Proposed Changes to the Technical Specifications  
Related to the License Amendment Request for the  
Upgrade of the Instrumentation and Control System  
for the  
Armed Forces Radiobiology Research Institute  
TRIGA Reactor

4 April 2022

*Figure 2-1 – Ranges of Operation for the NMP-1000*

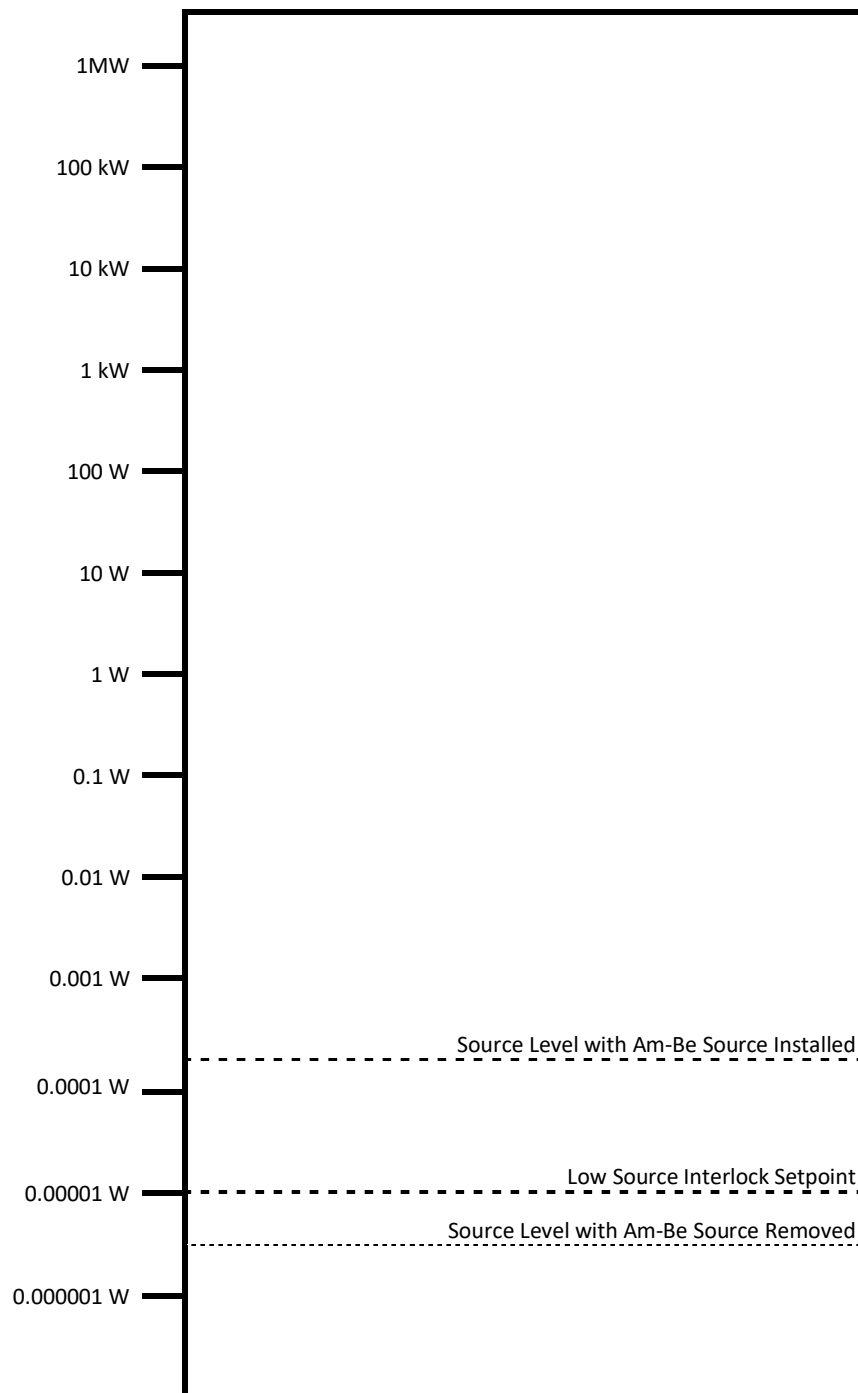
From Figure 2-1, it is shown that a setpoint of  $1 \times 10^{-5}$  watts is well above the level when the source is removed which provides assurance that channel is operating correctly by detecting sufficient source neutron prior to startup. Therefore, it is concluded that the proposed change to Table 3 of TS 3.2.2 for the source range interlock will continue to perform the design function required by this channel.

*Figure 4-2 – Core Dolly Limit Switch Diagram*

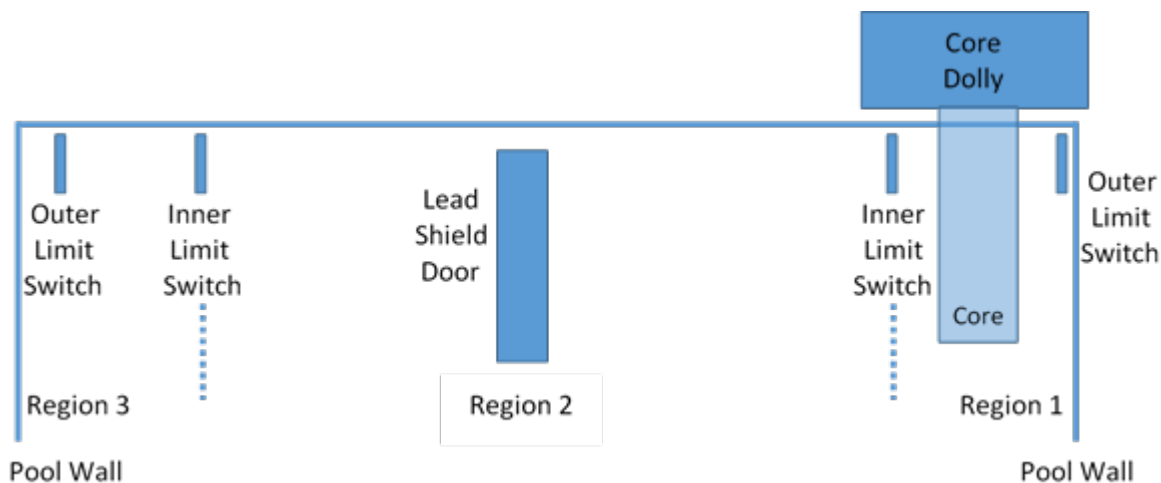
For each region there are two limit switches that will stop core dolly movement - the inner and outer limit switches. Refer to Figure 4-2 for a diagram of the switches. The outer limit switch stops the core dolly when it reaches the far end of the travel to prevent contacting the pool liner. The outer switches cannot be overridden. To prevent contact with the lead shield doors, the inner limit switch stops the core dolly from further movement if the lead shield doors are not fully opened.

Figure 4-4 – Core Dolly Override Switch

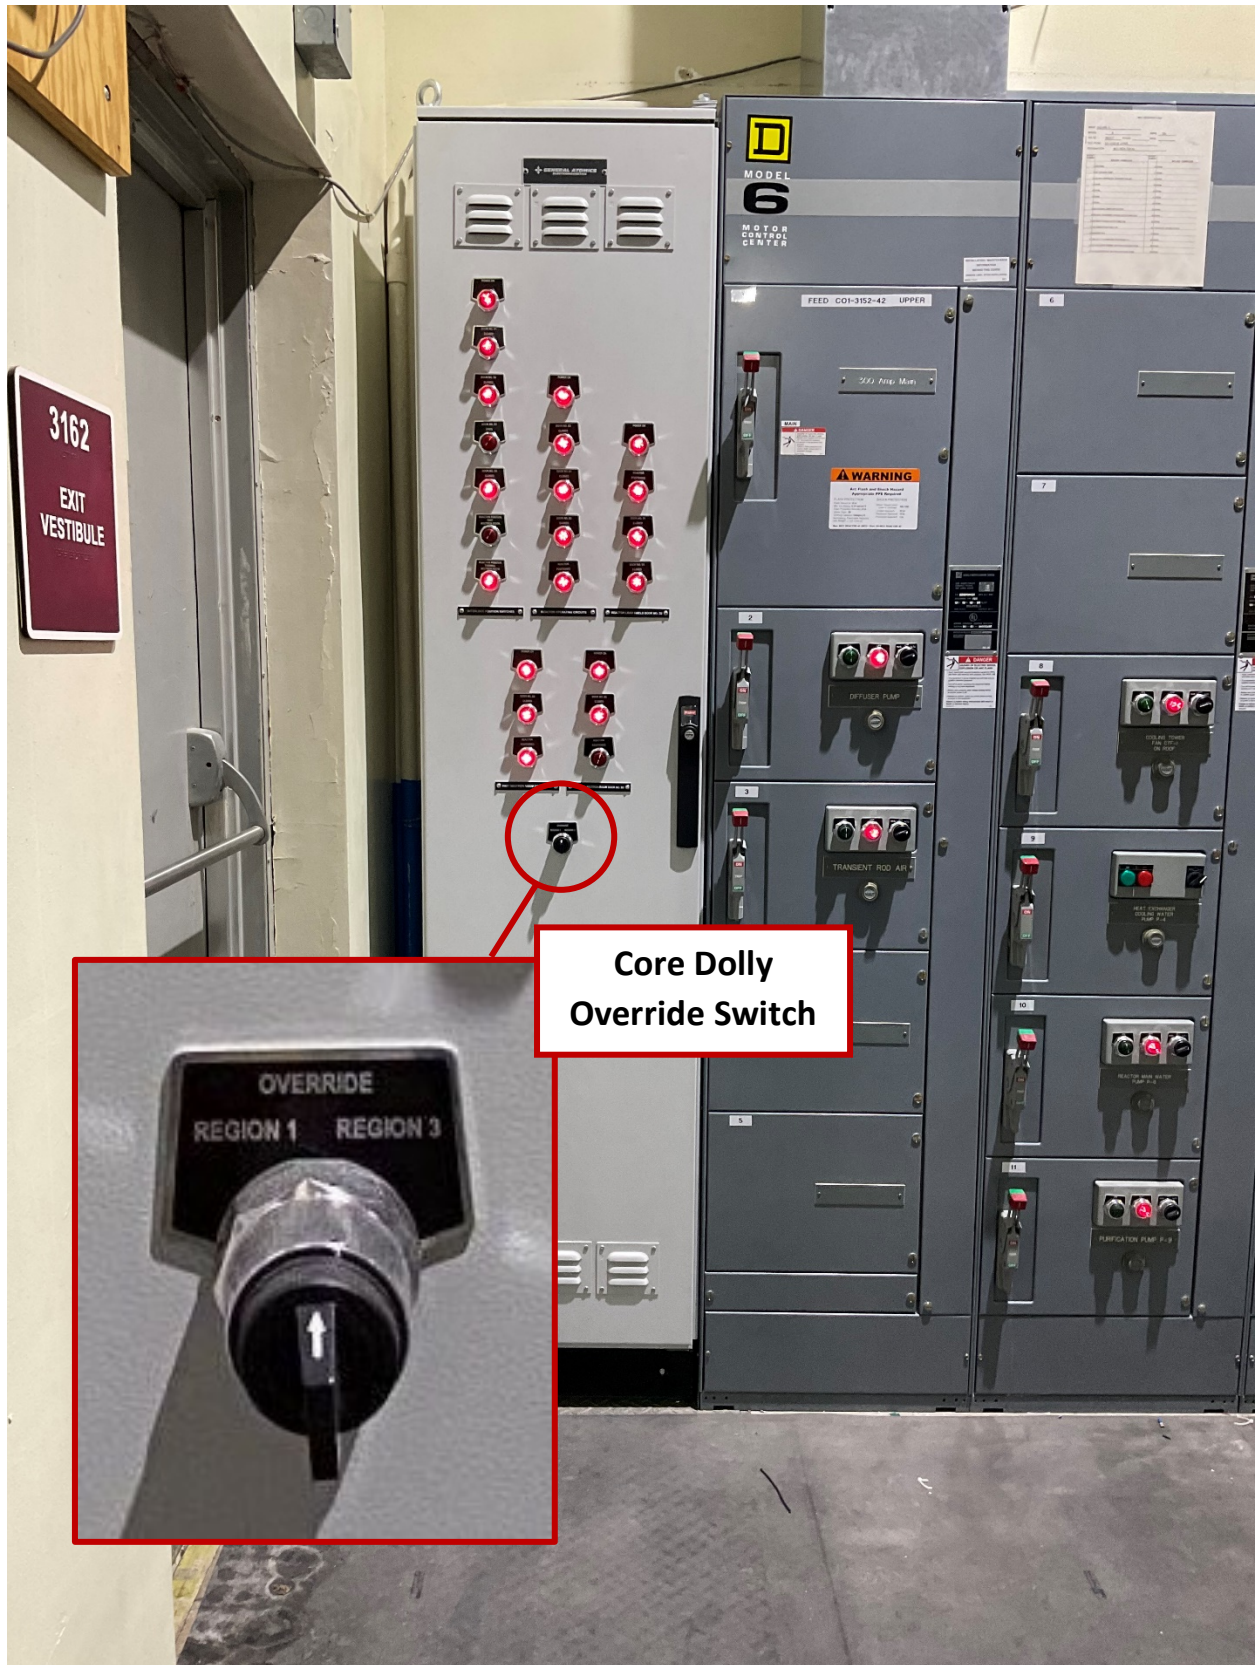
As part of the digital instrumentation and control upgrade, a core dolly override switch was added to the front of the Facility Interlock Cabinet (FIS). The O&M Manual briefly describes the override switch as toggle switch RP2. Refer to Page 3-28 of the O&M Manual and Drawing T3A100E840 Rev B. Figure 4-1 shows a close up of the switch, while Figure 4-4 shows that location of the switch on the FIS cabinet.

- a. With the lead shield doors open, neither exposure room plug door can be electrically opened.
- b. The core dolly cannot be moved ~~into~~ in region 2 with the lead shield doors closed except during the use of the core dolly interlock override switch.
- c. The lead shield doors cannot be opened to allow movement into the exposure room projection unless a warning horn has sounded in that exposure room, or unless two licensed reactor operators have visually inspected the room to ensure that no personnel remain in the room prior to securing the plug door.
